WIRE BULLETIN NO. 145  
"FAA DOA EA-4 APPROVED"

DATE: January 29, 1975  
TO: Owners and Operators of Specified AA-5B Aircraft  
SUBJECT: AA-5B UPPER ENGINE MOUNT BOLT INSPECTION  
SERIALS AFFECTED: AA5B-0003 thru AA5B-0005, AA5B-0007 thru  
AA5B-0011 and AA5B-0013 thru AA5B-0015.  
TIME OF COMPLIANCE: Within 25 hours of operation

Upper Engine Mount Assembly  
(Typical 2 places)

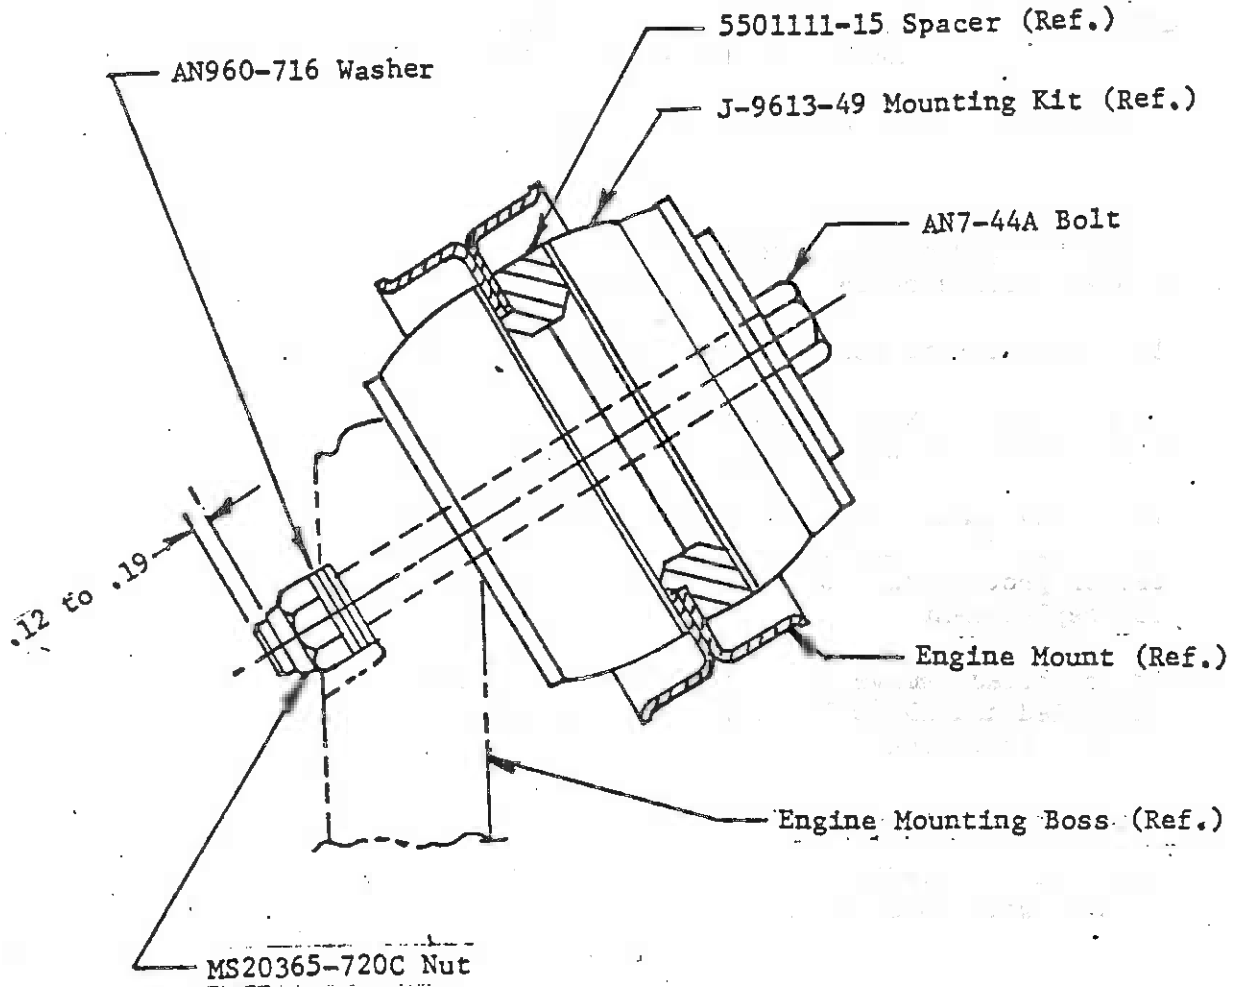
1. Inspect upper engine mounts for bolt protrusion through nut. Proper protrusion is .12 to .19 inch.
2. If protrusion is correct, no further action is required.
3. If protrusion exceeds .19 inch, support engine, remove upper bolts and nuts and inspect threads for damage.
4. If thread damage is evident, the damaged bolt or nut must be replaced and AN960-716 washers added under nut to provide proper protrusion. Use AN7-44A Bolt and MS20365-720C Nut for replacement.
5. If no thread damage is evident, the bolt and nut maybe re-installed and AN960-716 washers added under nut to provide proper protrusion.
6. Torque engine mount bolts to 450 to 500 inch pounds.
